Access Compliance Report

Public Rights-of-Way

(Curb Ramps)

Intersection ID: N/A	Main Street: BONNY BRIDGE CT	Cross Street: N/A	Location: S
ADA ID: FFE6114EC08F	Ramp Type: BlendTrans1	Initial Pass/Fail: Fail	Overall Compliance: No
Codes/Mitigation Info/Possible Solution		Field Measurements/Component Compliance	
Severity Score: 10

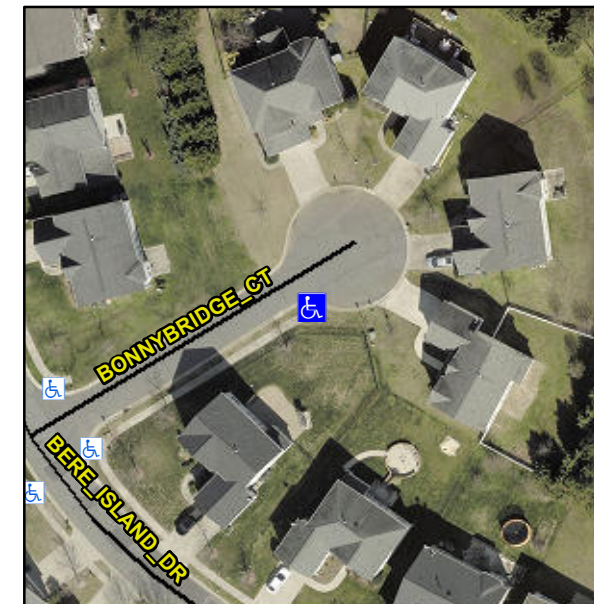
Not Found, R304.5.1, R304.5.3

Compliance	Description	Data	Compliance	Description	Data
N/A	Ramp Length (in)	47.0	Yes	BlendTrans Slope (%)	3.9
No	Ramp Width (in)	45.5	No	BlendTrans XSlope (%)	3.1
N/A	Flare Type LT	N/A	N/A	Flare Type RT	N/A
N/A	Flare Slope LT (%)	N/A	N/A	Flare Slope RT (%)	N/A
N/A	Flare Traversable LT?	N/A	N/A	Flare Traversable RT?	N/A
N/A	Landing Length (in)	N/A	N/A	DWS Provided?	N/A
N/A	Landing Width (in)	N/A	N/A	DWS Contrast?	N/A
N/A	Landing Slope (%)	N/A	N/A	DWS Length (in)	N/A
N/A	Landing X Slope (%)	N/A	N/A	DWS Full Width?	N/A
N/A	Landing Curb? (Y/N)	N/A	N/A	DWS Offset (in)	N/A
N/A	Shared Landing?	N/A			
N/A	Gutter Ponding?	N/A	N/A	Gutter Slope (%)	N/A
N/A	Gutter Lip Ht (in)	N/A	N/A	Gutter X Slope (%)	N/A
N/A	Painted X Walk1?	No	N/A	Painted X Walk2?	N/A
	X Walk 1 Direction	To NW		X Walk 2 Direction	N/A
	X Walk 1 Width (in)	N/A		X Walk 2 Width (in)	N/A
	X Walk 1 Slope (%)	3.7		X Walk 2 Slope (%)	N/A
	X Walk 1 X Slope (%)	1.8		X Walk 2 X Slope (%)	N/A

N/A	Ramp inside XWalk1?	N/A	N/A	Ramp inside XWalk2?	N/A
	Road Slope (%)	1.8		Clear Space?	N/A
	Road X Slope (%)	3.7	N/A	Clear Space to XWalk (in)	N/A
N/A	Any Obstructions?	N/A	N/A	Storm Grate/Utility Hazard?	N/A
	Obstruction Type			Storm Grate/Utility Type	
		N/A			N/A
			Yes	Surface Condition? (G/P)	Good
			No	Curb Slope (%)	13.0

Remove & Replace Curb Ramp With Two New Directional Ramps or Equivalent.
